**ADDENDUM NO. 1**

PROJECT: Winslow HVAC Systems Upgrades – School #5 ES9782.01

BID NO.: 2025-07

PARTIAL FIRST FLOOR @ KITCHEN  
LIGHTING PLAN 2  
1/4" = 1'-0" E21

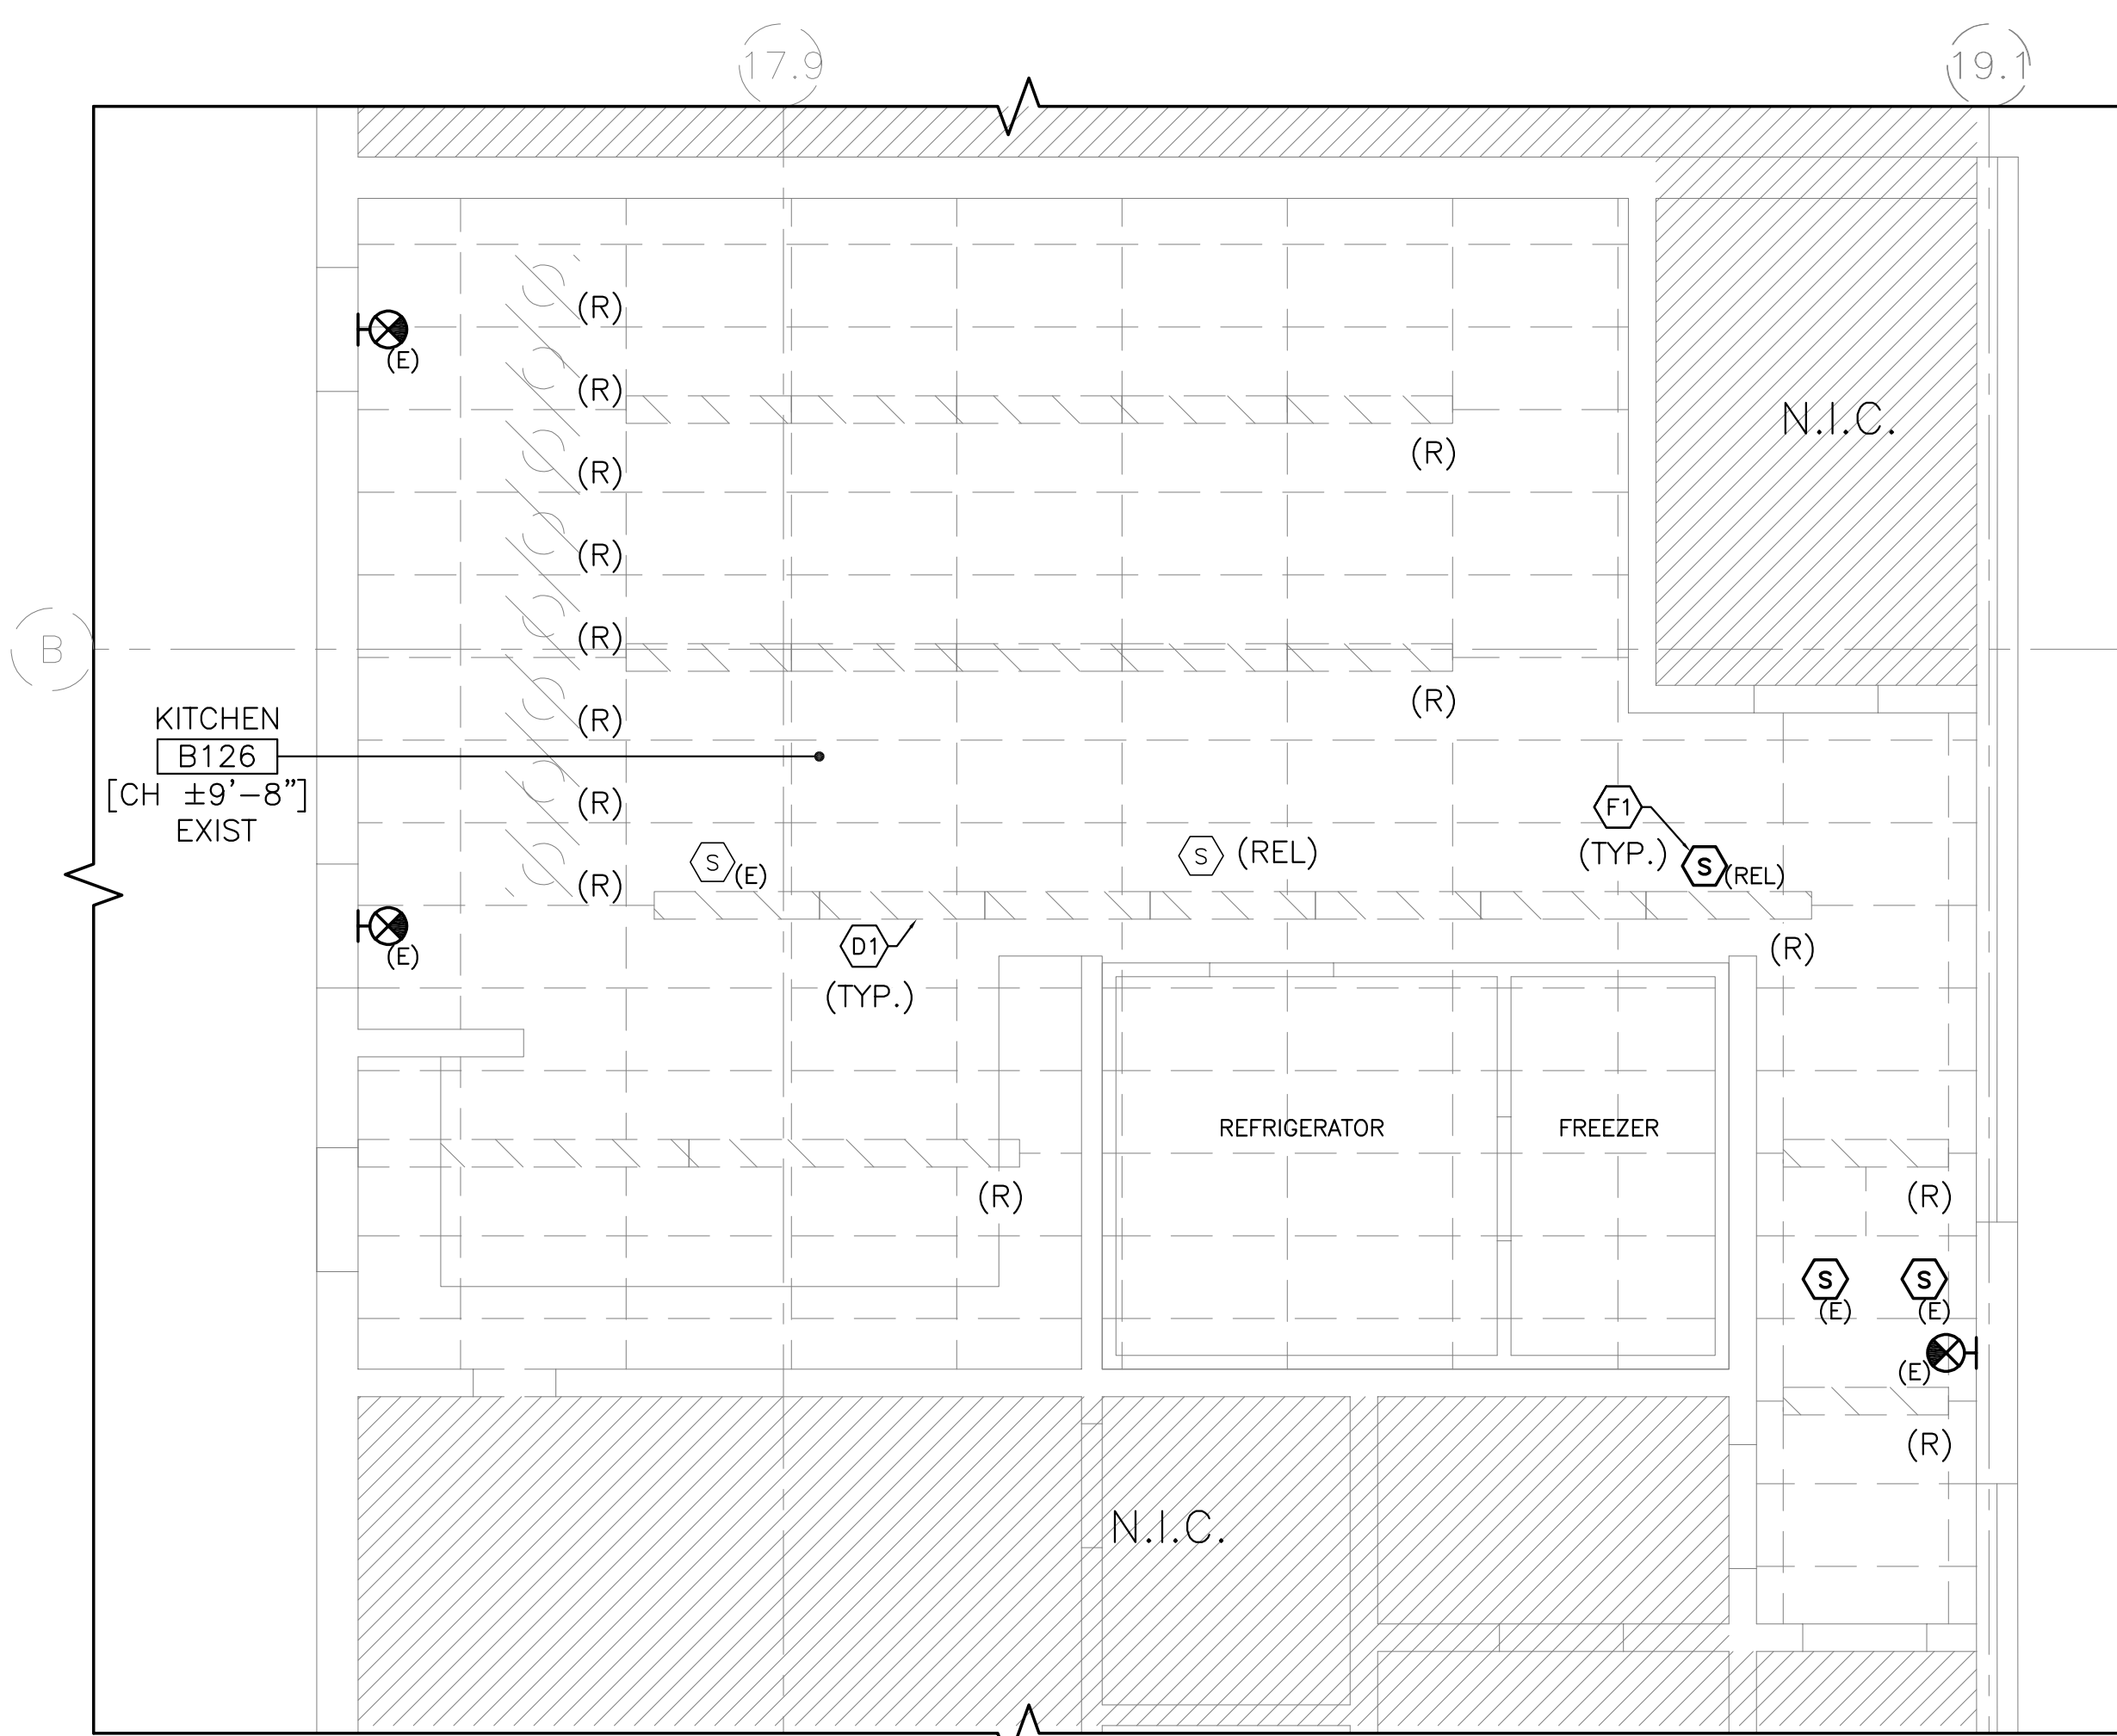
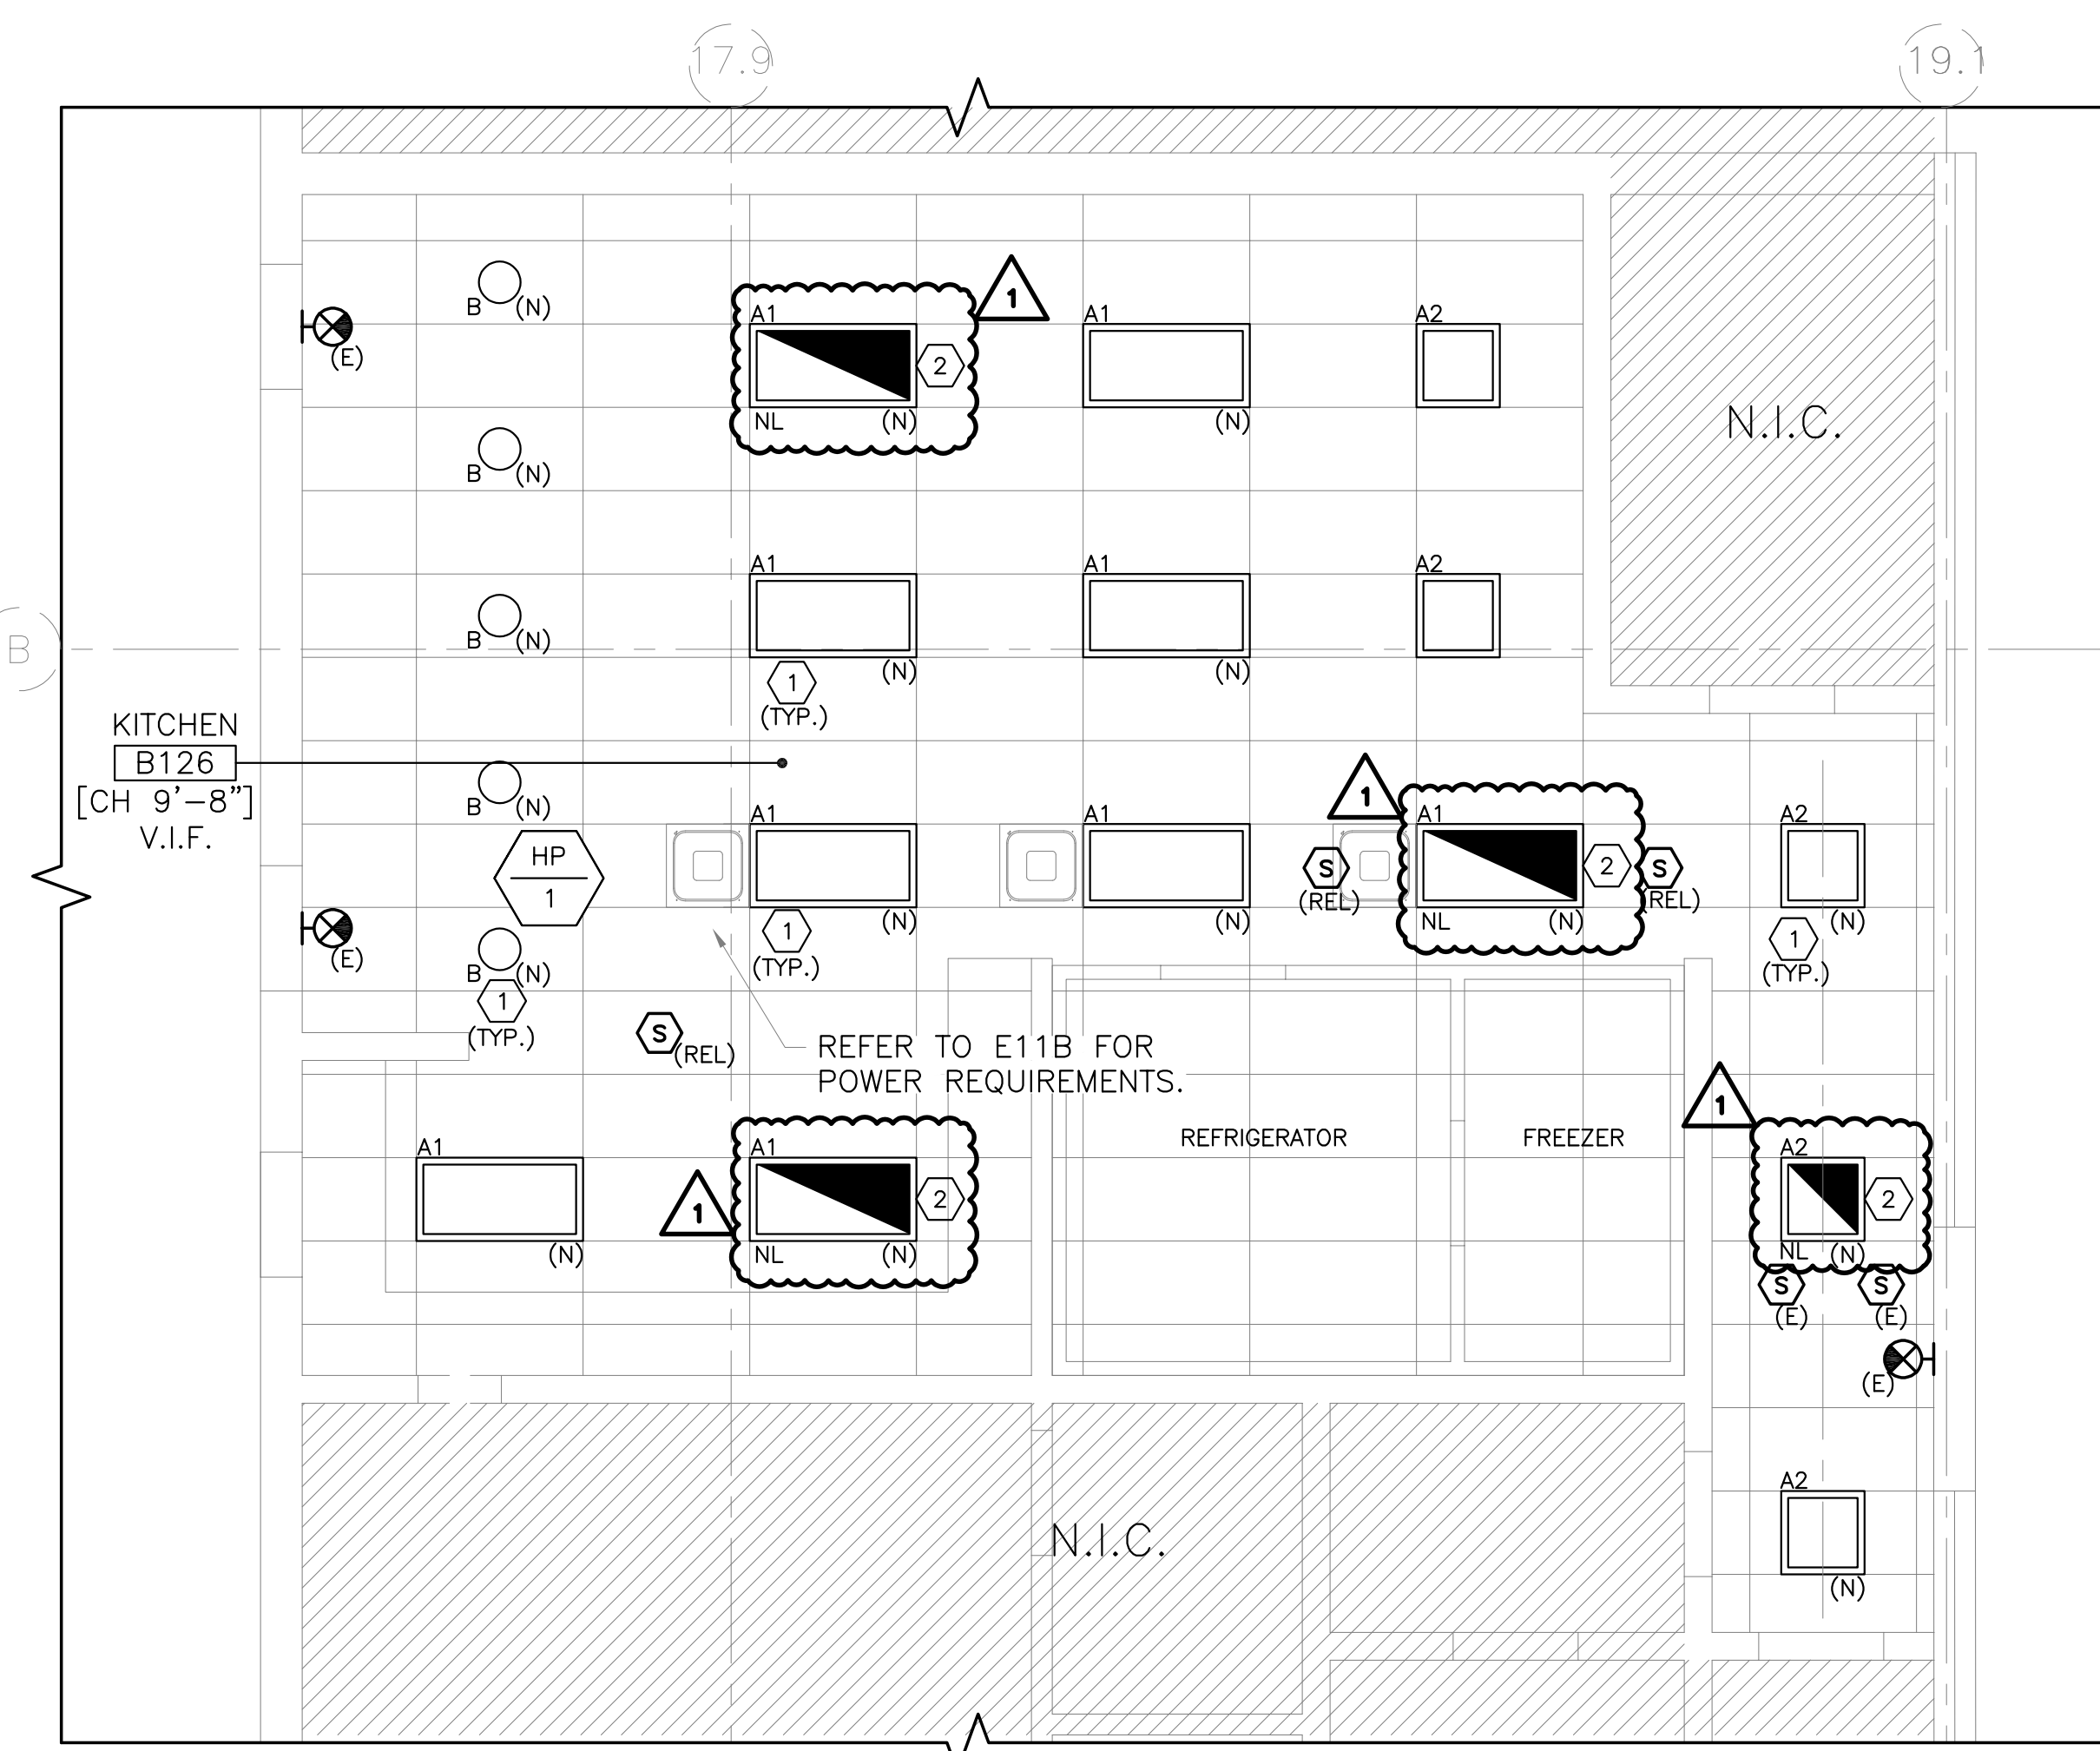
**10. Q: Sheet #E 21 – Do not install battery backup light fixtures-This should be tied into**

A: New light battery backed fixtures not purchased and fixtures added to KHP-Circuit 3.
